T.I. no.: 2019 - 23 Updated: -	Topic: Solid state relay SCP
-------------------------------------------------	-------------------------------------

Date: 26.11.2019	Priority	Need for action
Affected machines: SCP	High	As soon as possible
From serial number: 1929 /	Medium	On next visit to the machine
As of date: —	X Low	X FYI only

(SSR) solid state relay

SSR SOLID STATE RELAY
072 615 OLD

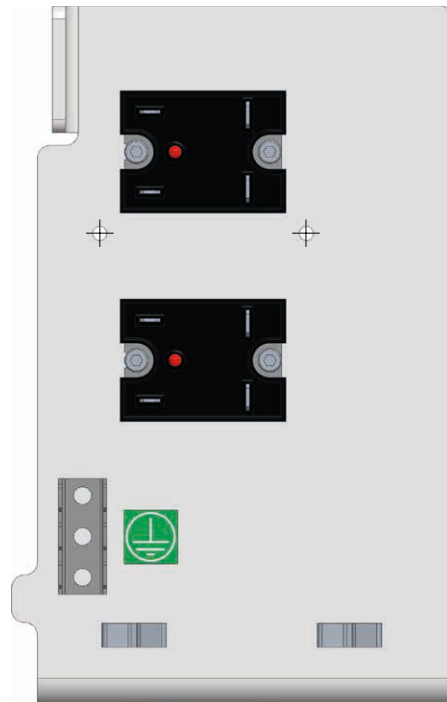
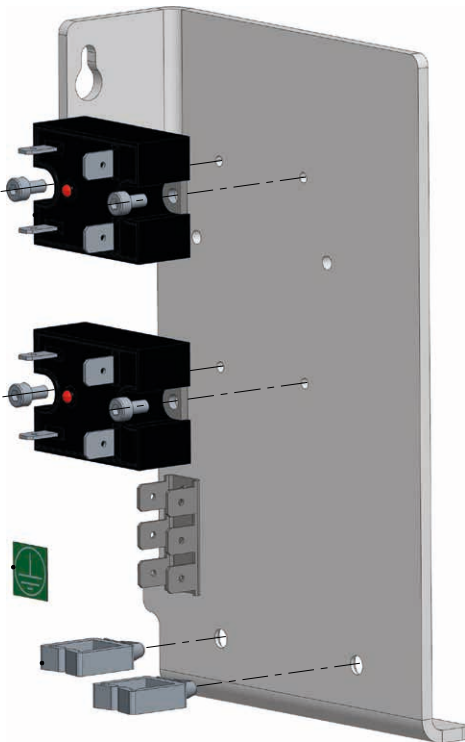
To avoid a cost increase, **072 615** will be replaced by (SSR) solid state relay **072 044**.

Since the new relays **072 044** do not fit on the old bracket, the complete assembly must be replaced when new relays are installed for the first time.

In other words, remove the old assembly (bracket and relay), install the new assembly (new bracket with new relays).

- Replace relay assembly **074 535**. (Remove the old bracket with the old relays).
- Install new relay assembly **074 535**. (Install the new bracket with the new relays).

The Schaerer Coffee Prime is now equipped with two SSR 072 044, the predecessor had only one SSR installed.
